# **Civil SSDA - Flood Assessment & Stormwater Management Report**

**Lang Walker AO Medical Research  
Building - Macarthur**

Prepared for **BVN** / 25 March 2022

## Response to EES Comments

Figure 19- Flood Levels & Depths (PMF) – Proposed Conditions (Ground Floor)

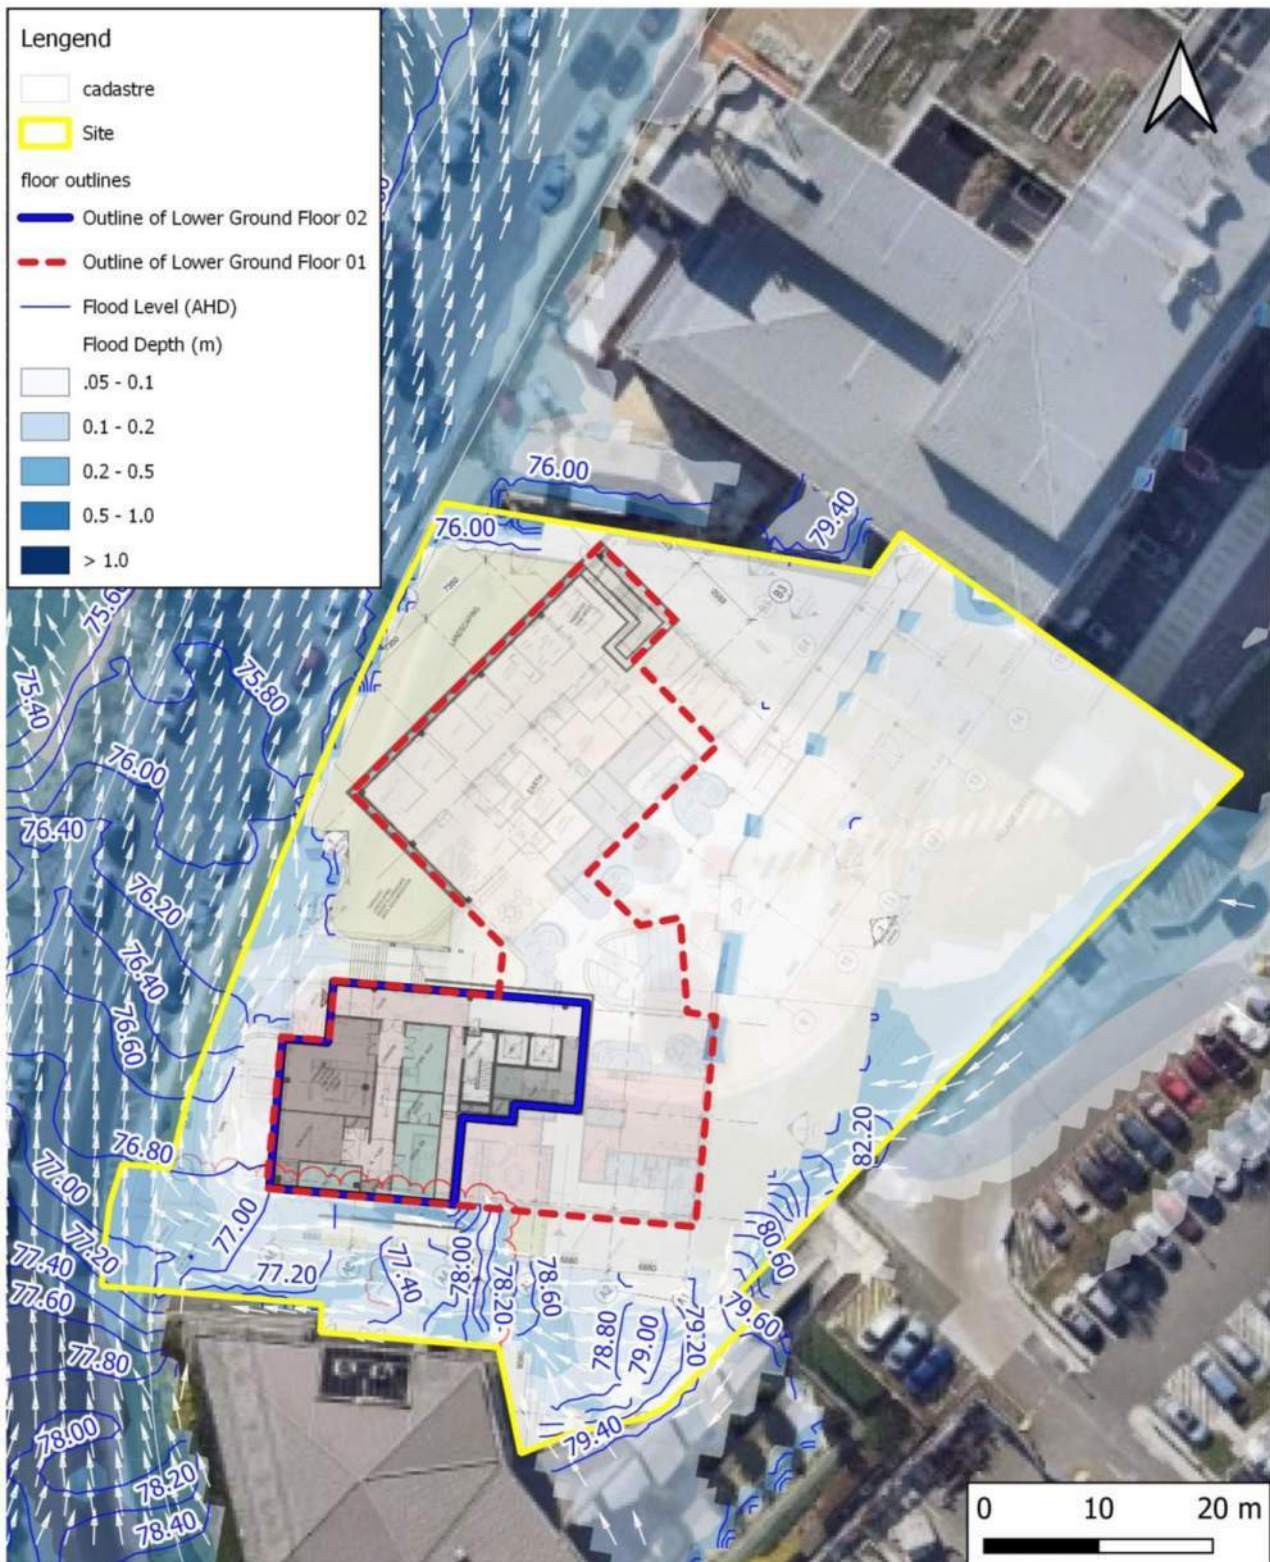
EES Comments	TTW Response
<ul style="list-style-type: none"> <li>▪ EES has concerns regarding the flood model accuracy. The proposed conditions flood mapping shows flooding inside the building footprint, most notably in Figure 19 of the Civil SSDA – Flood Assessment and Stormwater Management Report Lang Walker AO Medical Research Building – Macarthur (the flood report). The building should be blocked out in the model and no flooding should be present within the building footprint. If the building is not blocked out, impacts will not be properly assessed.</li> </ul>	<ul style="list-style-type: none"> <li>▪ The proposed building now shown as blocked out in the images as they were in the model.</li> <li>▪ No flooding is present across the proposed building footprint. (Refer Section 4.5 and Figure 16 &amp; Figure 19).</li> <li>▪ Figures 17,18 and 19 show flooding below Ground Level, toward the western side of the building, where there this level overhangs Lower Ground Levels 01 and 02. The flooding in this area remains outside the building footprint. The flooding at Lower Ground Floor 01 and 02 are shown in figure 20 and 21 respectively.</li> <li>▪ Images have been updated to include the building outlines above and below respective floor levels.</li> </ul>

Figure 22 – Flood Panning levels (FPLs) Vs. Proposed Finished Floor Levels (FFLs) – Lower Ground 02

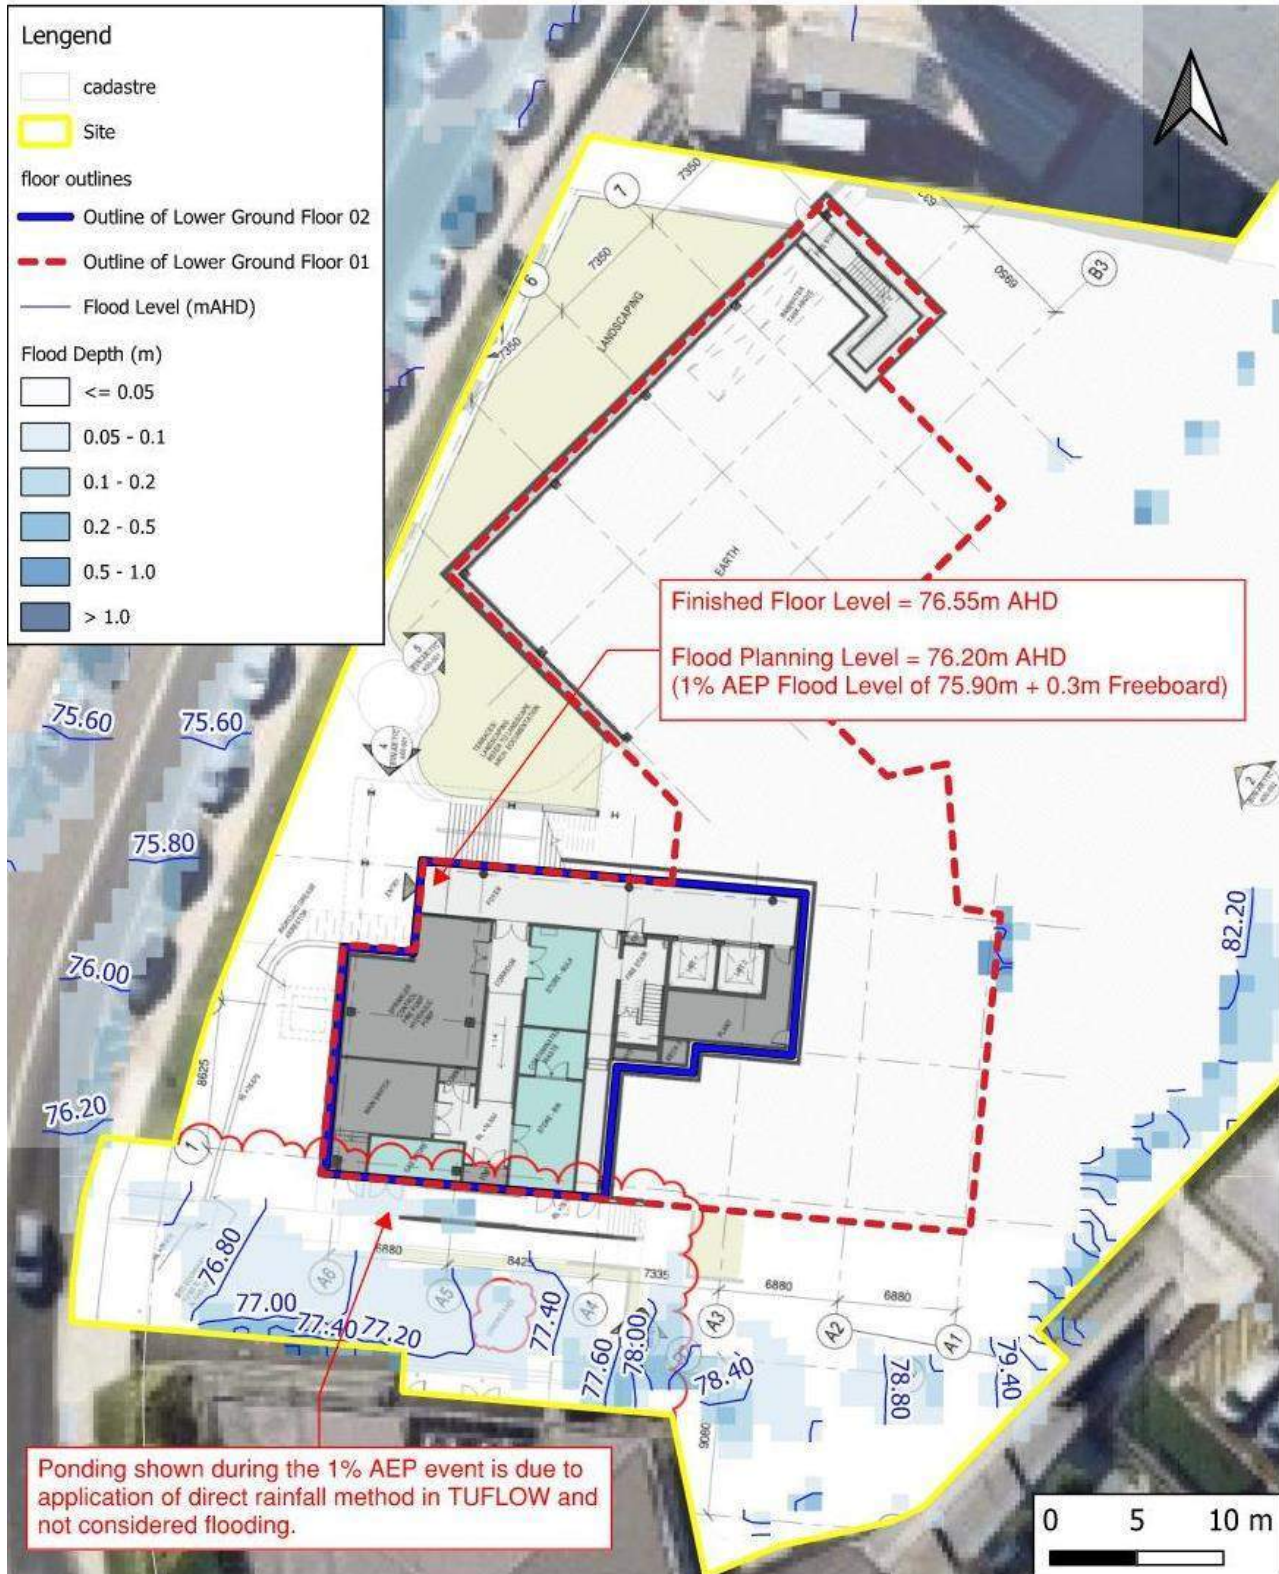
EES Comments	TTW Response
<ul style="list-style-type: none"> <li>▪ Section 5.3.1 Flood Levels Adjacent to the Proposed Building's Openings Received architectural plans indicate that the proposed entry level to Lower Ground 02 is 76.10m AHD which is 0.23m above the 1%AEP flood level of 75.88m AHD and 4mm above the adjacent PMF flood level of 76.06m AHD.</li> </ul>	<ul style="list-style-type: none"> <li>▪ Additional Figure 22, Figure 23 &amp; Figure 24 have been provided to confirm that Council's flood planning requirements have been met for all building openings. Refer Section 6.0 of the report for more details.</li> </ul>
<ul style="list-style-type: none"> <li>▪ The Flood report establishes that the proposed Finished Floor Level for the Lower Ground 02 is 76.55m AHD which is above the minimum required FFL of 76.38m AHD (1% AEP flood level of 75.88m AHD plus 500mm freeboard).</li> </ul>	<ul style="list-style-type: none"> <li>▪ Additional Figure 22, Figure 23 &amp; Figure 24 have been provided to confirm that Council's flood planning requirements have been met for all building openings. Refer Section 6.0 of the report for more details.</li> </ul>

Received architectural plans indicate that the proposed Lower Ground 02 will be used for services and storage area and is not habitable. The proposed Finished Floor Level (FFL) of Lower Ground 02 is 76.55m AHD which is above the minimum required flood planning level of 76.05m AHD (1% AEP flood level of 75.75m AHD adjacent to the main western entry plus 300mm freeboard).

Figure 25 – Flood Impact Assessment Map (1% AEP Flood event)

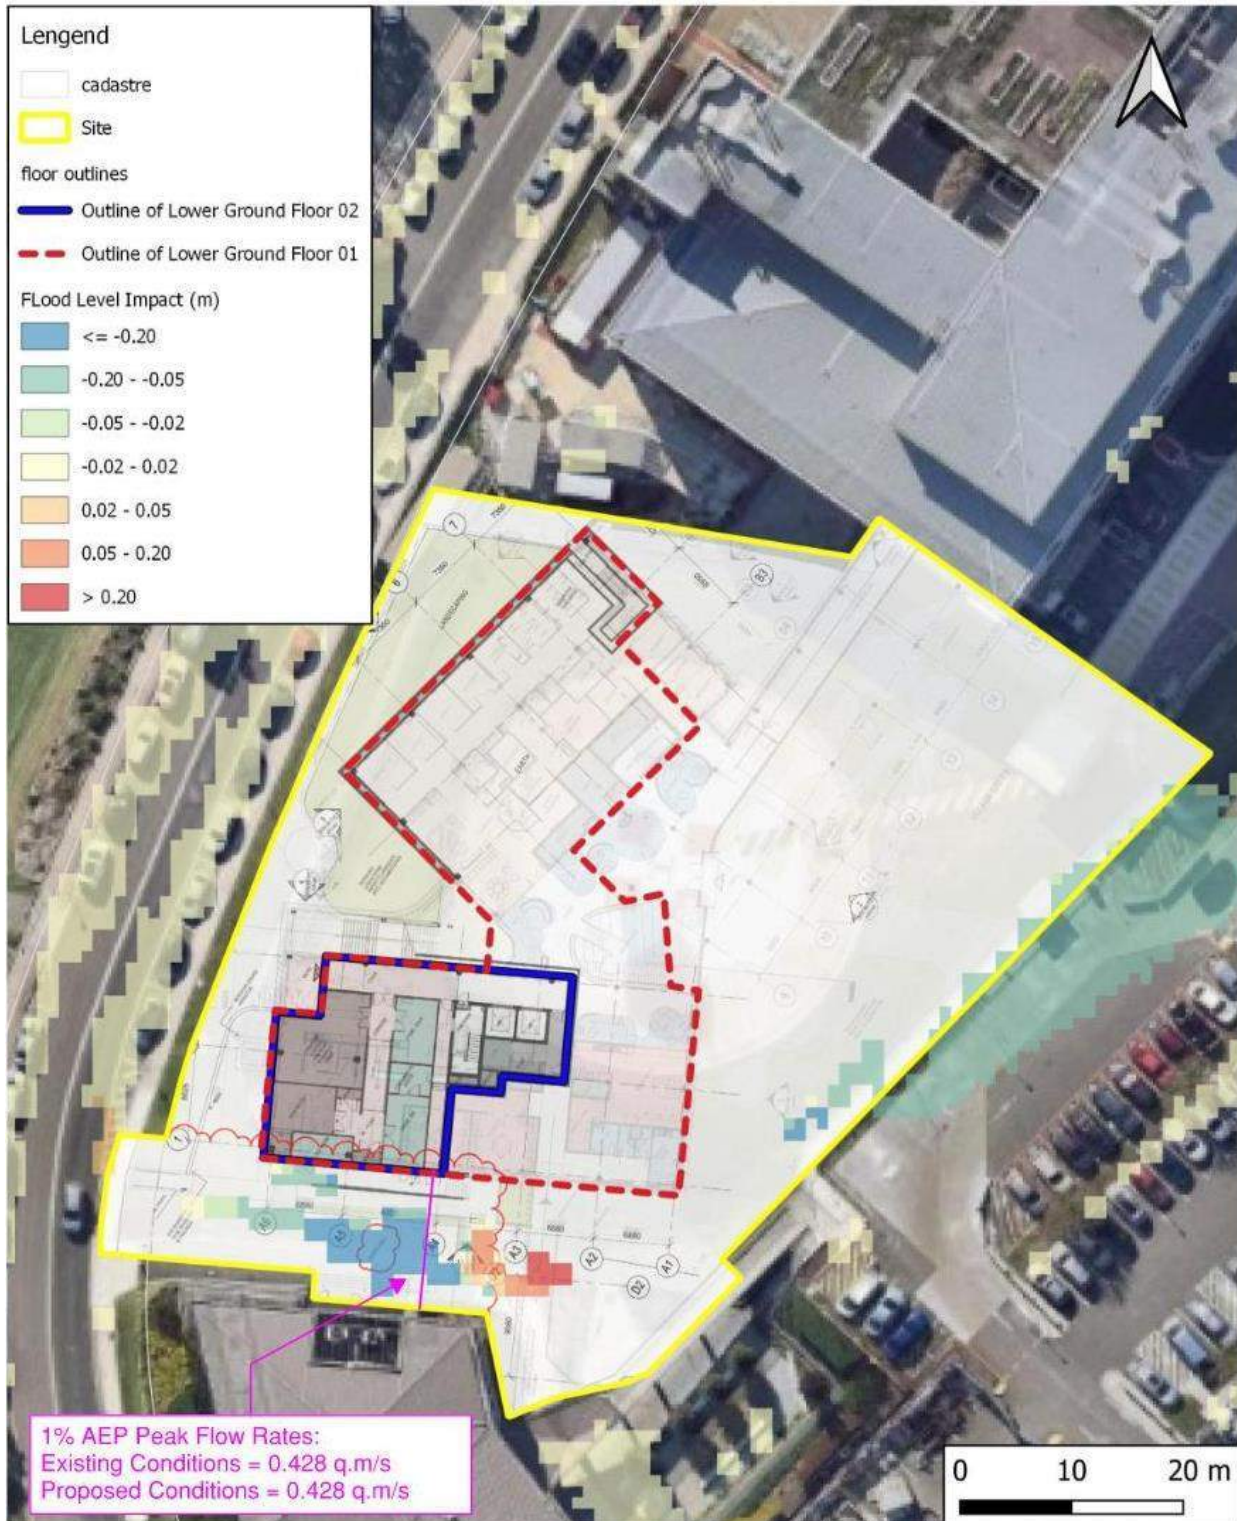
<ul style="list-style-type: none"> <li>▪ Further detail is required on flood impacts. The Flood Impact Assessment Map for the 1% AEP flood event does not allow assessment of significant impacts because a band of -20 mm to +20 mm has been used. No significant impact is typically considered to be within -10 to +10 mm. The mapping should be revised accordingly. Further, due to the potentially sensitive nature of adjacent land uses (hospital buildings), impact assessment is also required for the PMF event and a corresponding map should be provided.</li> </ul>	<ul style="list-style-type: none"> <li>▪ Flood impact assessment map with a band of 10mm to +10mm is now shown in Figure 25. The impact map shows no adverse offsite flood impacts beyond ±10mm anywhere beyond the development boundary in the 1% AEP flood event (Refer 6.1).</li> <li>▪ Flood impact assessment map for the PMF event is now provided in Figure 26. The development does not have any detrimental effect on adjacent buildings during the PMF event.</li> </ul>

Campbelltown Council Comments	TTW Response
<ul style="list-style-type: none"> <li>▪ The site is impacted by overland flow from the car park at the hospital. Council discussed this matter with the proponent's engineers previously, and it was indicated that an overland flow path to the north of the proposed building would be included in the design. This flow path is not evident on the plans, However it is needed and should collect the overland flow and manage its discharge to the pipe drainage system in Parkside Crescent. Overland flows over the footpath, or discharge to the road surface are not permissible.</li> </ul>	<ul style="list-style-type: none"> <li>▪ The existing overland flow path for the upstream catchment (including the existing car park east of the site) is along the southern site boundary which drains onto the Crescent Park Road as shown in Figure 8 and presented clearly in Figure A1 of Attachment A.</li> <li>▪ The existing overland flow path has been maintained in the proposed development along the southern site boundary (see Figure 16 and Figure A2 of Attachment A).</li> <li>▪ The proposed pipe drainage system for the site is designed to cater for storm events of up to 5% AEP (minor event) as per the ARR minor and major drainage system requirements.</li> <li>▪ Minor storm event for the site is identified based on Table 4.5 of the Campbelltown Council DCP (2015).</li> <li>▪ The existing pipe network has been assumed to be fully blocked in the 1% AEP and PMF events. This approach provides more conservative results as opposed to the condition where the additional drainage capacity of the pipes is considered.</li> <li>▪ The existing stormwater pipe network in Parkside Crescent does not have capacity to convey the existing overland flows in major flood events e.g., a 1% AEP flood or greater.</li> <li>▪ The proposed development does not have any adverse impact on the existing flood levels or overland flow paths outside the development area, including the Parkside Crescent and the footpath.</li> <li>▪ The Proposed condition slightly reduces the 1% AEP existing overland flow that runs along the southern boundary, refer to Figure 25.</li> </ul>

Nevertheless, a flood impact assessment was undertaken to ensure no negative flood impacts caused by the proposed development. As depicted in Figure 25, the flood impact map shows no offsite impacts beyond the  $\pm 10\text{mm}$  tolerance occurs outside of the development site during the 1%AEP flood event.
